## ADDENDUM NO. 3

Reference: Libbie Edwards School Remodel  
The Utah School for the Deaf and Blind  
DFCM Project No. 08260200

## ADDENDUM - 1

Project: Libbie Edwards School Remodel, Utah School For The Deaf and Blind

SG001

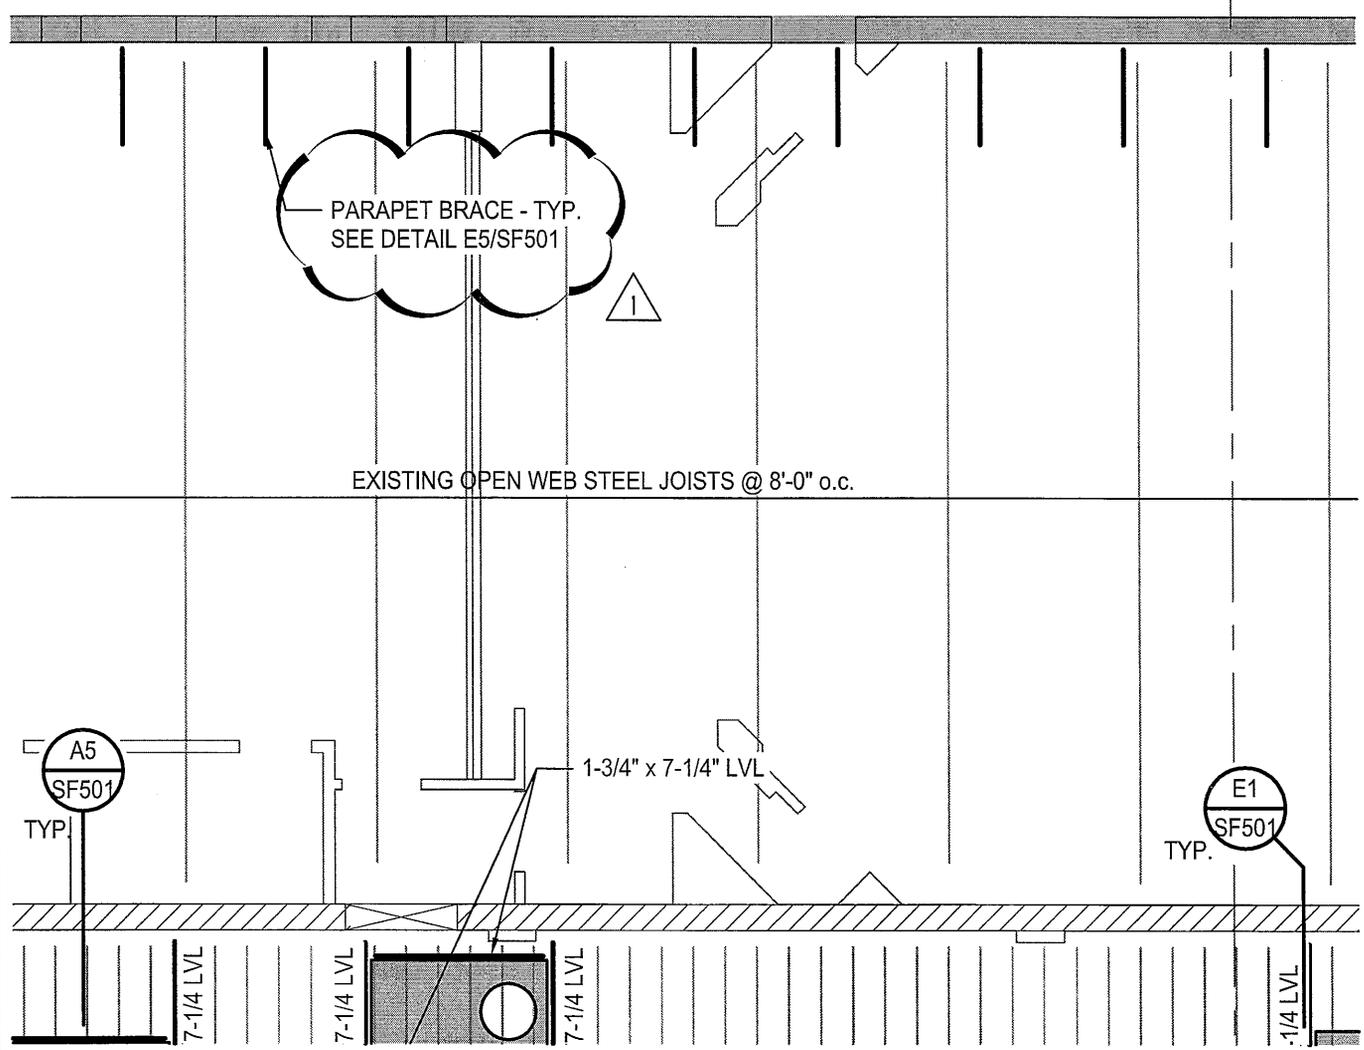
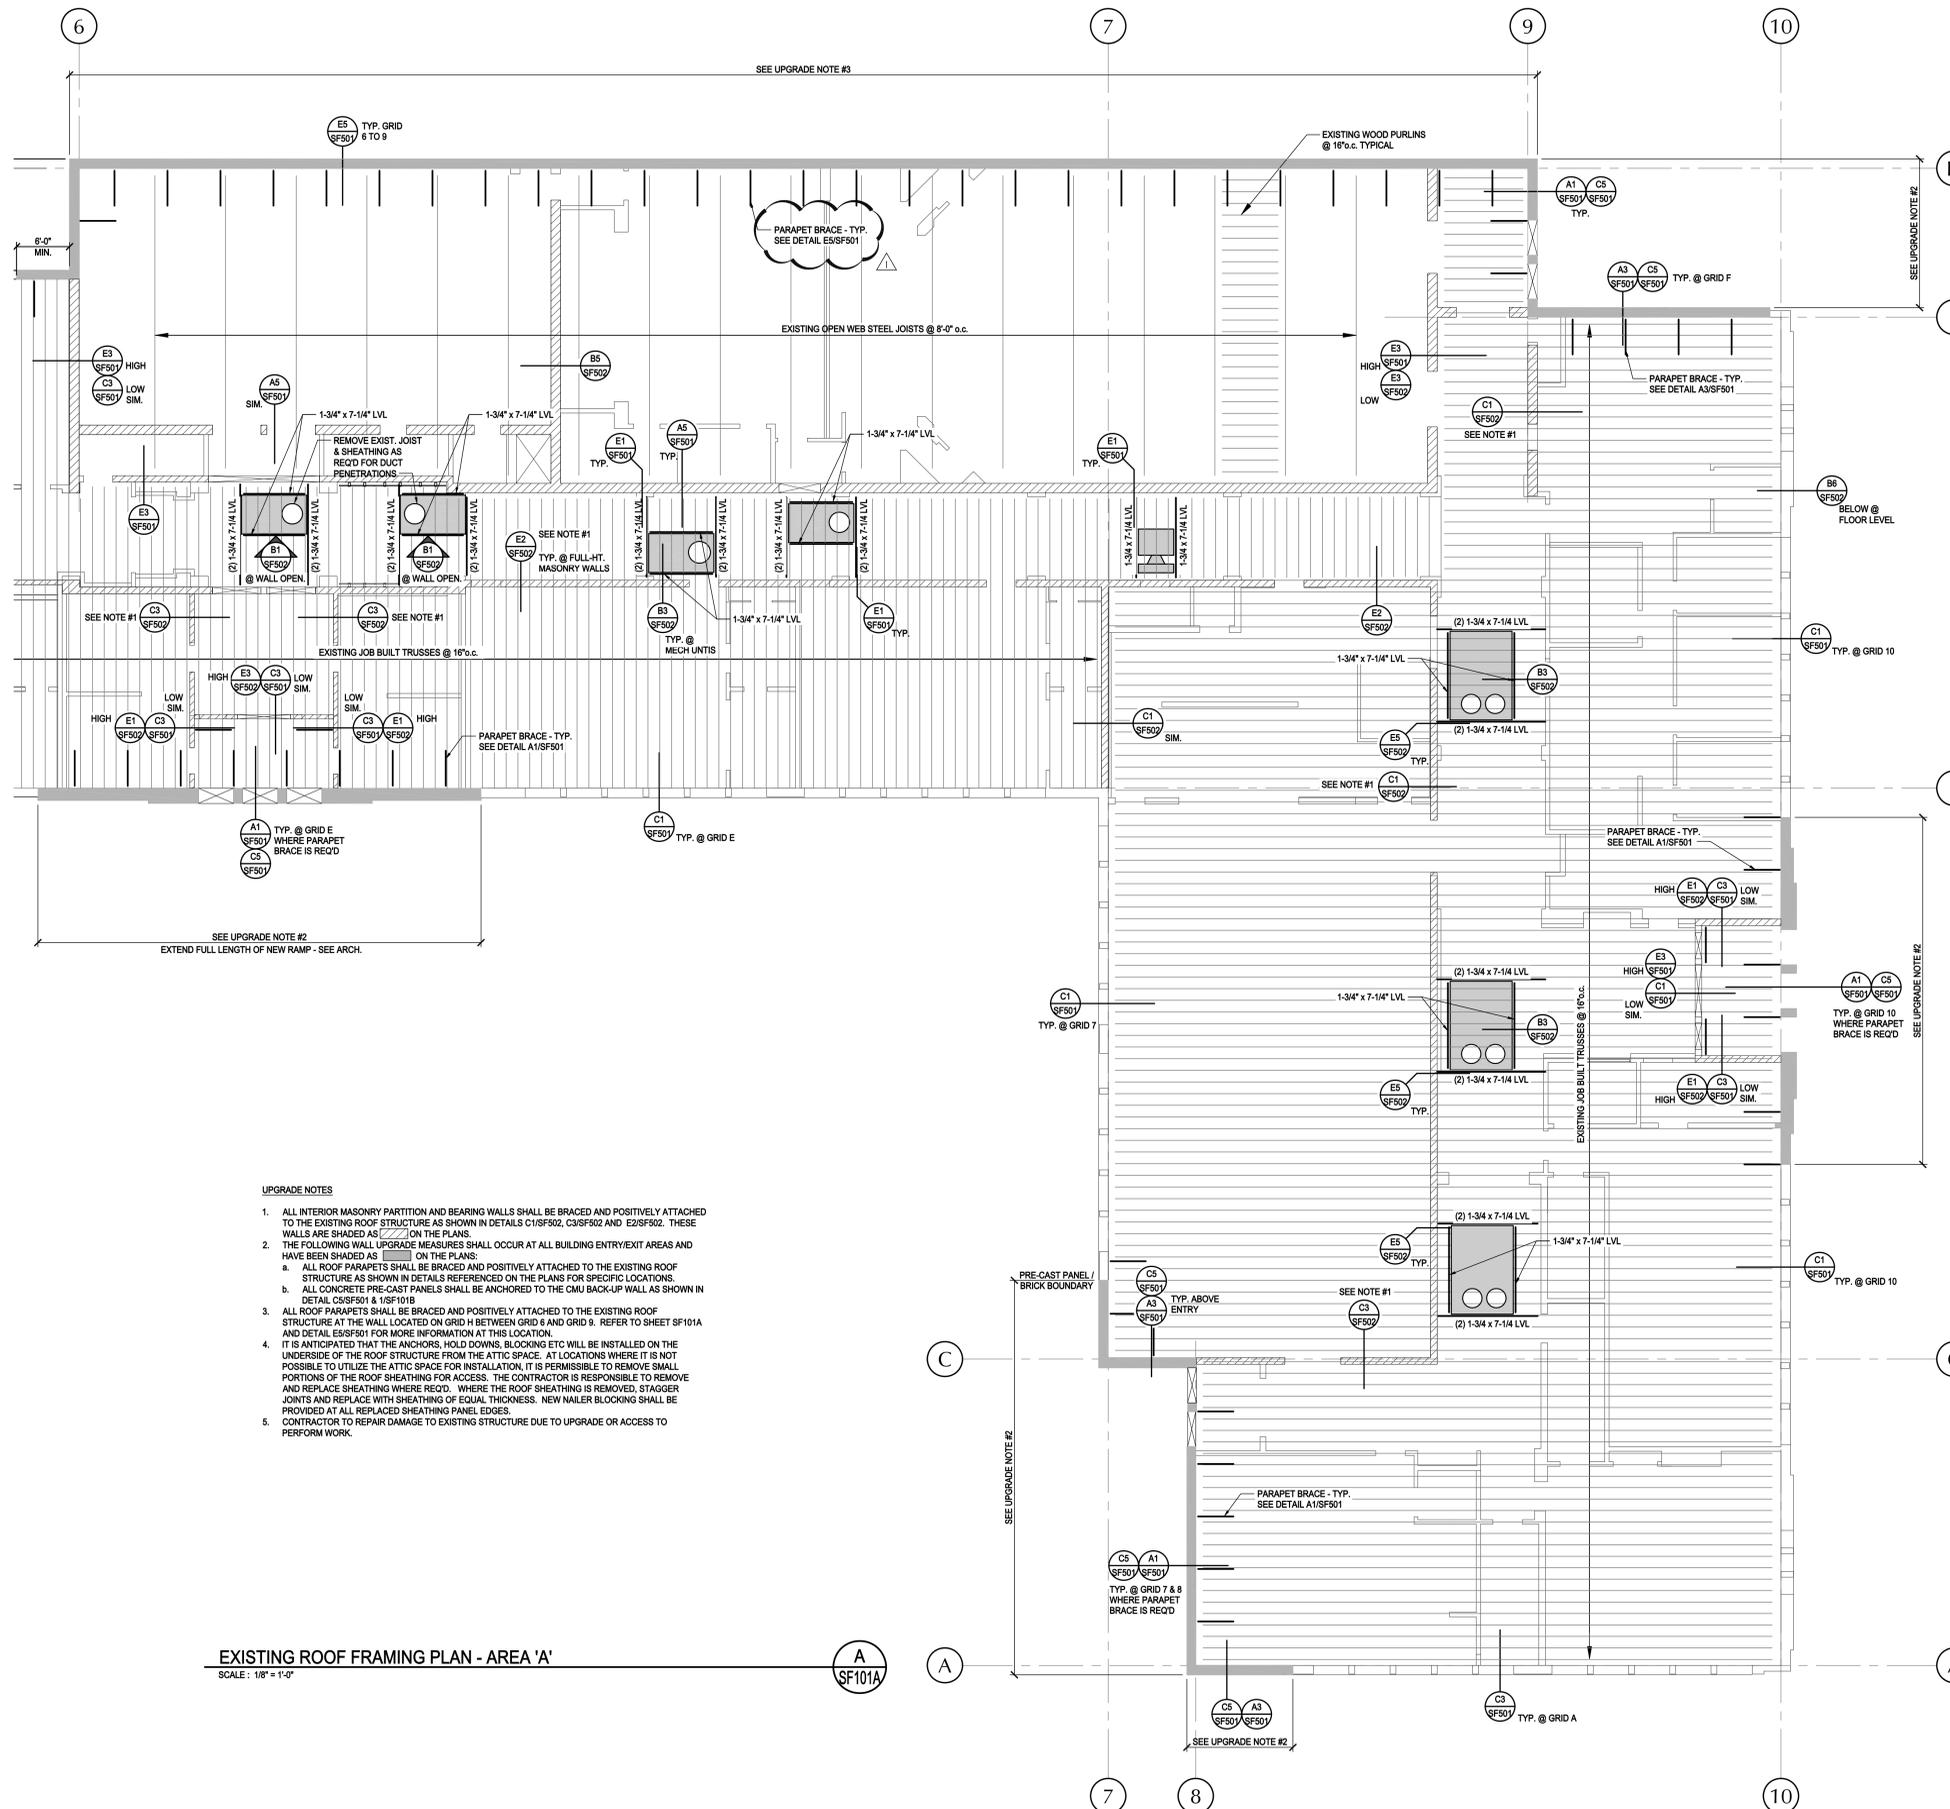
SG001: Add a note to the structural steel notes as shown on the attached drawing.

**EXIST. ROOF FRAMING - AREA 'A'**

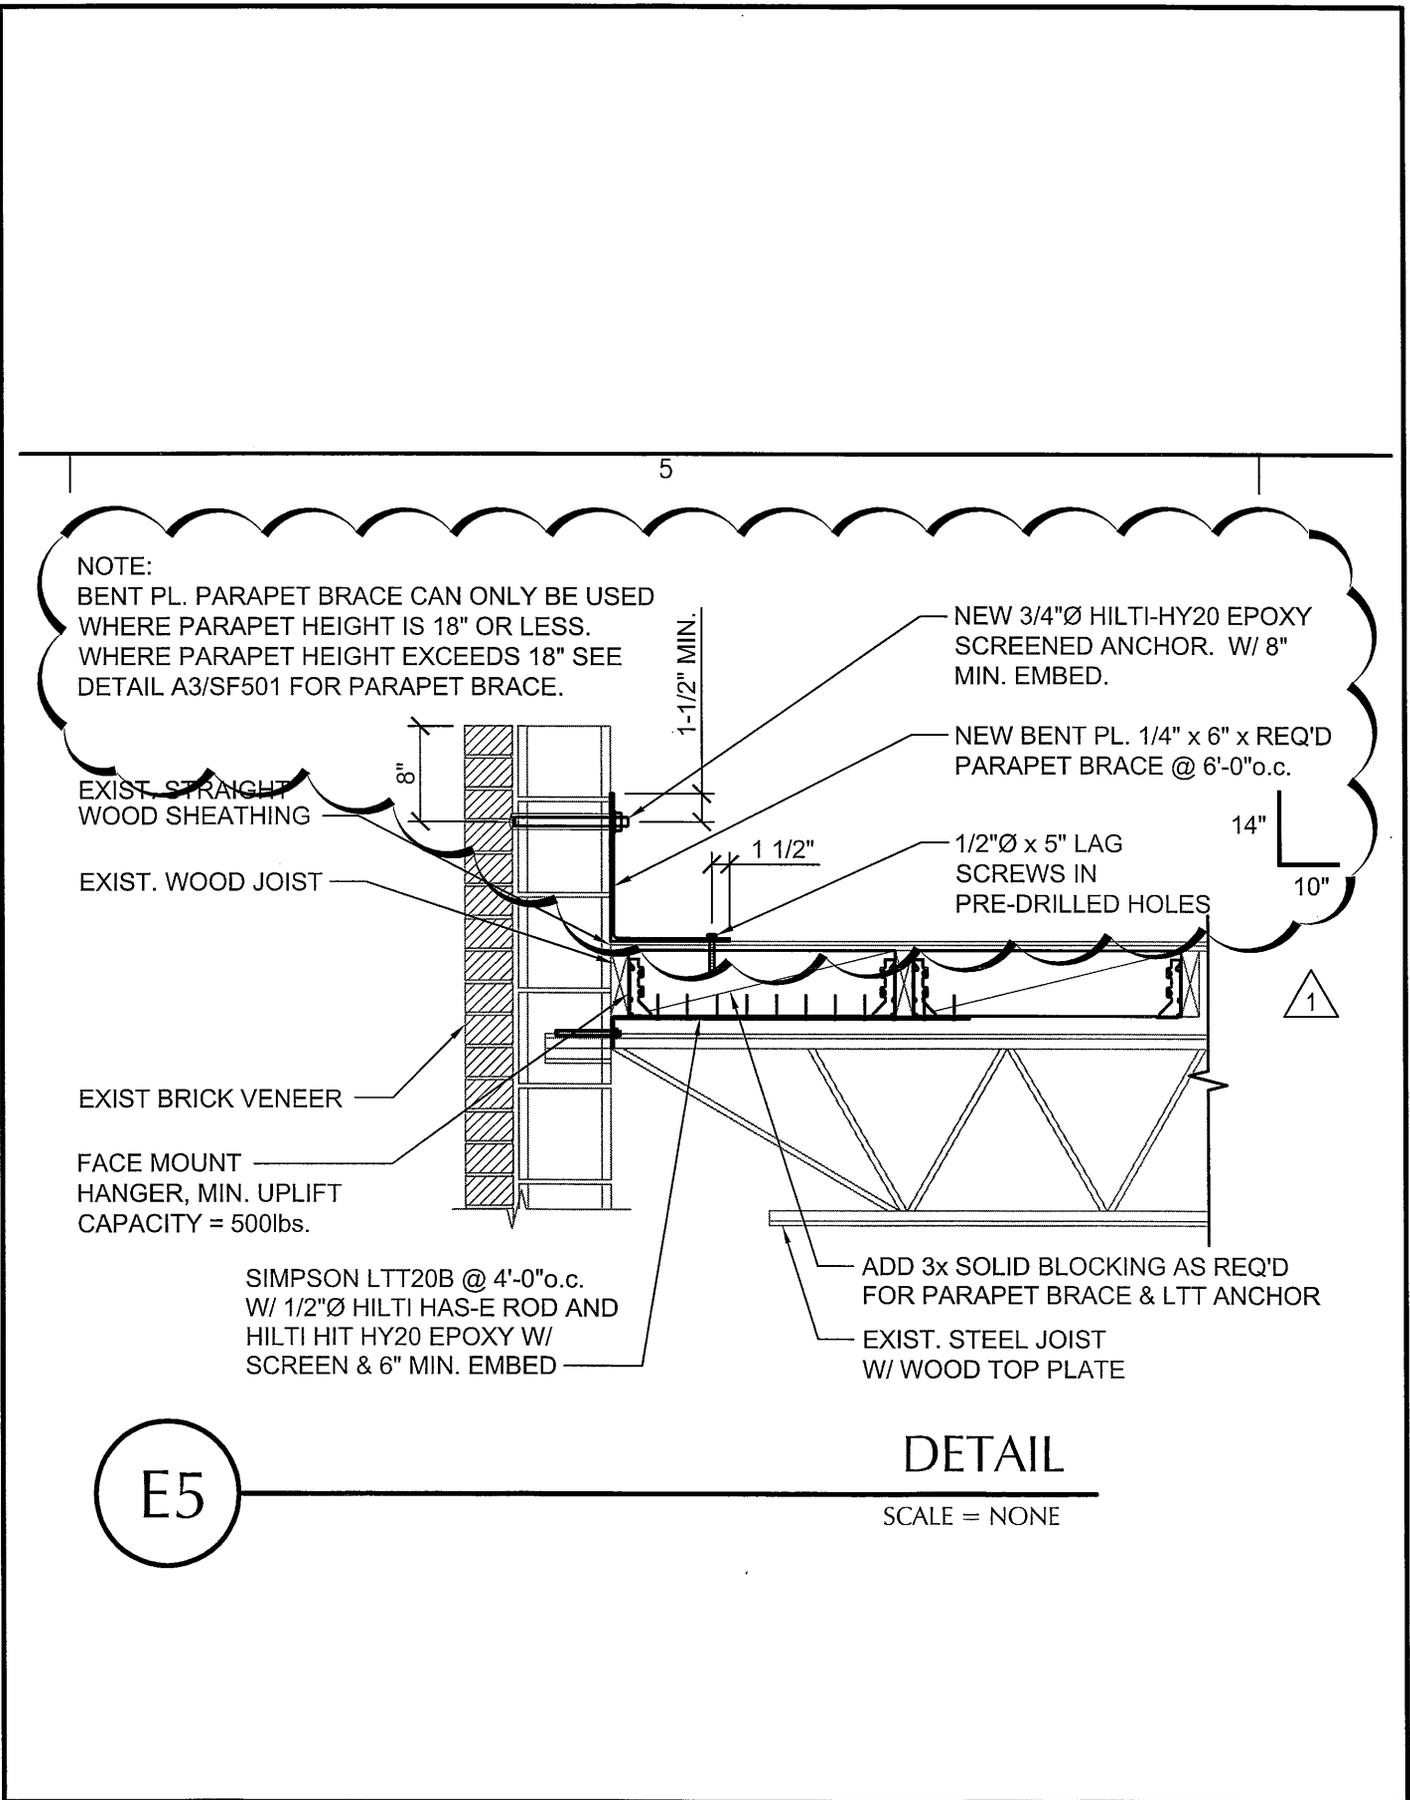
SF101A: The parapet brace call-out on Grid H referenced the wrong detail. Change this note as shown on the attached drawing to reference the correct detail.

**E5** DETAIL  
SCALE = NONE

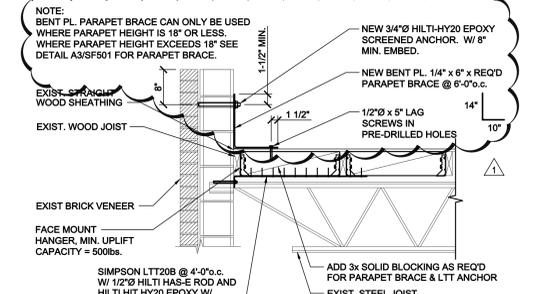
SF501: Revise the parapet brace in detail E5/SF501 as shown on the attached drawing.
